UNITED STATES PATENT AND TRADEMARK OFFICE

APPLICATION NO.	FILING DATE	FIRST NAMED INVENTOR	ATTORNEY DOCKET NO.	CONFIRMATION NO.
09/823,181	03/30/2001	Jingyue Ju	0575/62948/JPW/ADM/BJA	9161
7590 06/21/2005			EXAMINER	
John P. White, Esq. Cooper & Dunham LLP 1185 Avenue of the Americas New York, NY 10036			SISSON, BRADLEY L	
			ART UNIT	PAPER NUMBER
			1634

Office Action Summary	Application No. 09/823,181	Applicant(s) JU ET AL.	
	Examiner Bradley L. Sisson	Art Unit 1634

DETAILED ACTION

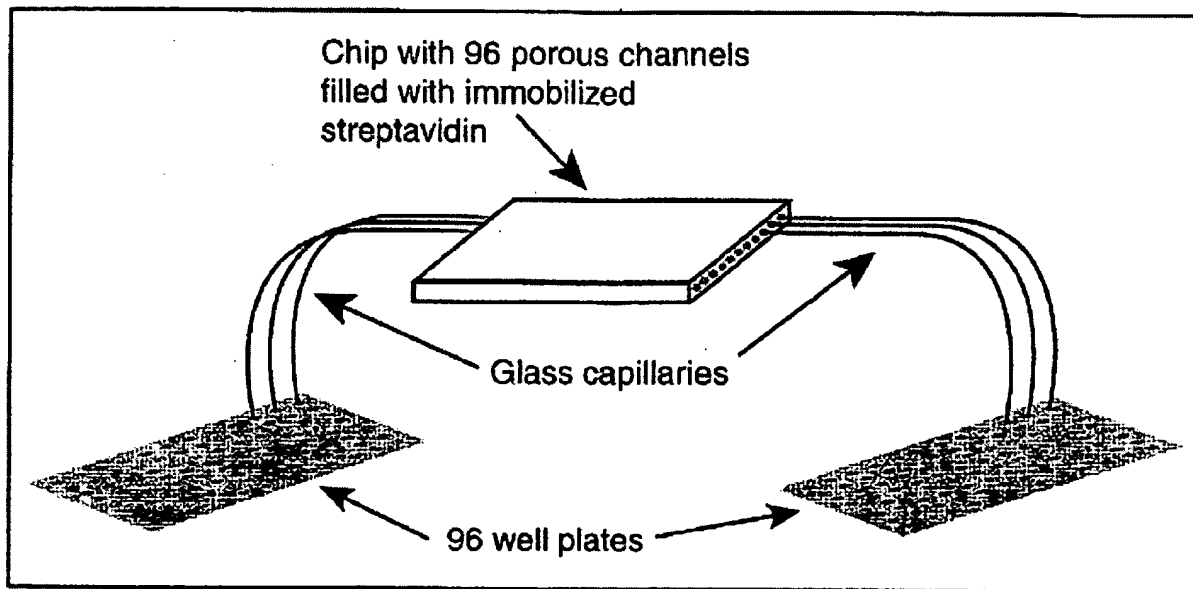
4. Acknowledgement is made of applicant having directed attention to page 32, lines 7-23; and page 48, lines 26-29, of the originally filed specification as providing support for the amendment to claim 74, the sole independent claim. Upon review of the cited passages, support for a generic claim comprising these newly added limitations cannot be found. While page 48, lines 26-29, does provide support for passing fluid through a channel multiple times, such is in respect to using "a glass capillary" and that the channels are in a "chip." Claim 74 does not recite these other limitations and a review of the cited passages, including Fig. 12, does not support their broader application.

12. As noted above, the claimed method has been interpreted as comprising a plurality of wells connected via a channel, where the channel and wells are within a chip. A review of the disclosure, however, fails to find an adequate written description of such a device. Rather, the specification has been found to provide a description via Fig. 12, of two 96-well plates that are connected via glass capillary tubes to corresponding single channels in a chip.

It is noted with particularity that the device described lacks any means for applying pressure such that any one, much less 96 different samples could be passed through the coated channels in one direction, much less back-and-forth, thereby permitting/enabling the binding of the DNA sequencing fragments.

As can be seen above, the means for processing the fluid would have each end of a channel in a single well, or the end of a channel could be connected to a plurality of wells. While pressure is to drive the fluid out of the well, through the channel, and into one or more wells, no means other than a perpetual motion could cause this feat to occur. The aspect of using a syringe is not suggested by the disclosure at page 48 or in the figures. Rather, the text at page 48 closely parallels Figure 12 (reproduced above).
